Re: Conditional Approval of General Electric's August 30, 2005 *GMA 4 Groundwater Quality Monitoring Interim Report for Spring 2005* and February 27, 2006 *GMA 4 Groundwater Quality Monitoring Interim Report for Fall 2005*, GE-Pittsfield/Housatonic River Site, Pittsfield, Massachusetts.

This letter provides the Environmental Protection Agency's (EPA) conditional approval of GE's August 30, 2005 *GMA 4 Groundwater Quality Monitoring Interim Report for Spring 2005* and February 27, 2006 *GMA 4 Groundwater Quality Monitoring Interim Report for Fall 2005*. This letter is subject to the terms and conditions specified in the Consent Decree that was entered in U.S. District Court on October 27, 2000.

Figure 1
GMA 4 Groundwater
Monitoring Network

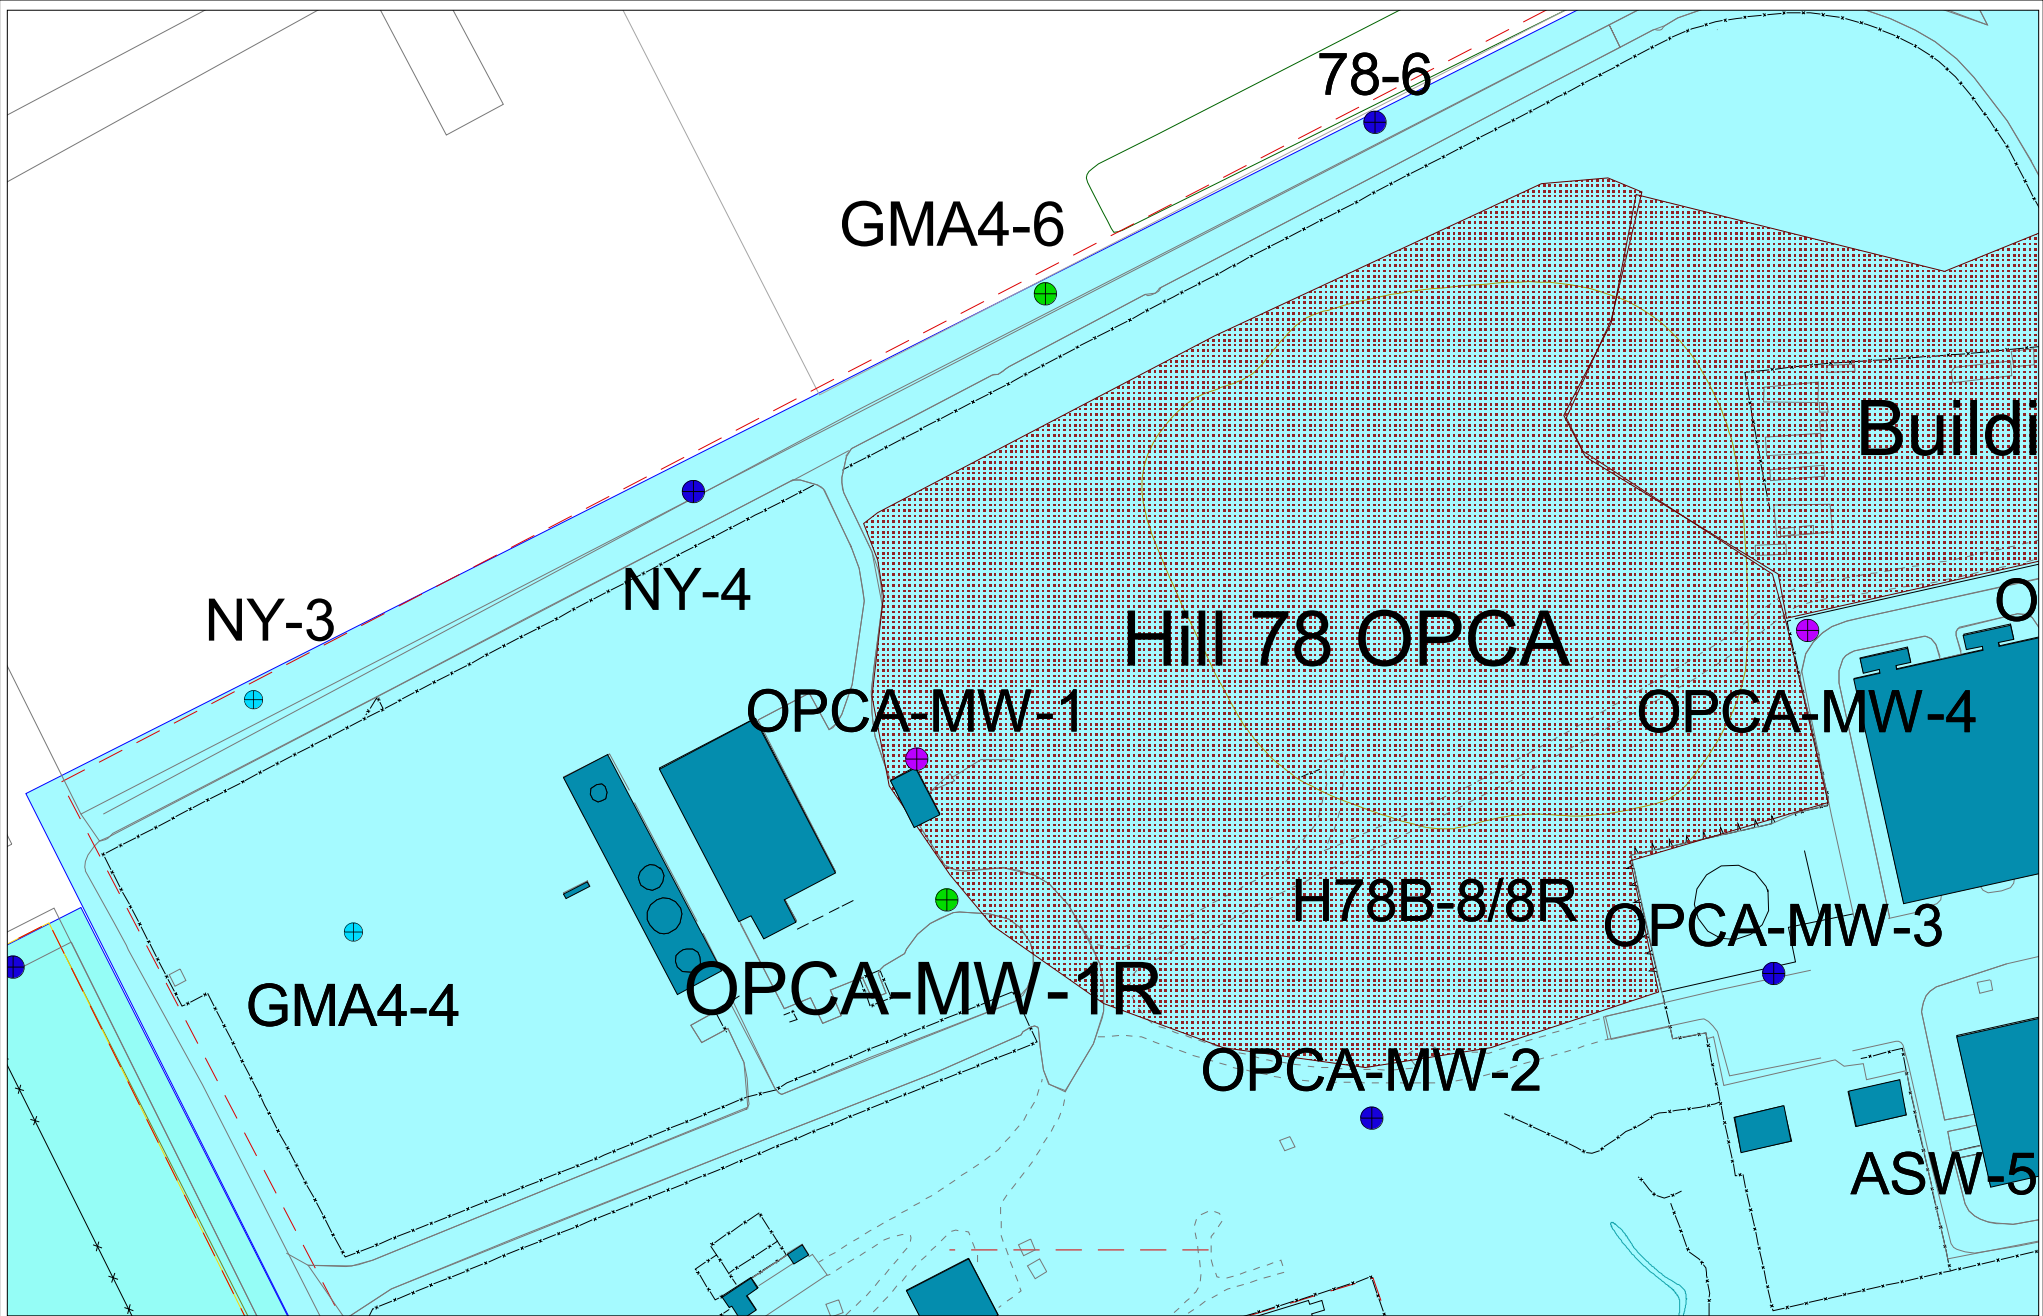
5. If consolidated wastes will be placed over OPCA-MW-1 as a result of the proposed shift of the Hill 78 OPCA footprint, GE shall decommission OPCA-MW-1 and replace it with OPCA-MW-1R which shall be located on the same side of the groundwater divide as the Hill 78 OPCA (see attached figure for approximate location). GE's proposal in Section 5.3.2 of their February 27, 2006 report, which is to use GMA4-4 as a replacement for OPCA-MW-1, is unacceptable because GMA4-4 is on the other side of the groundwater divide.
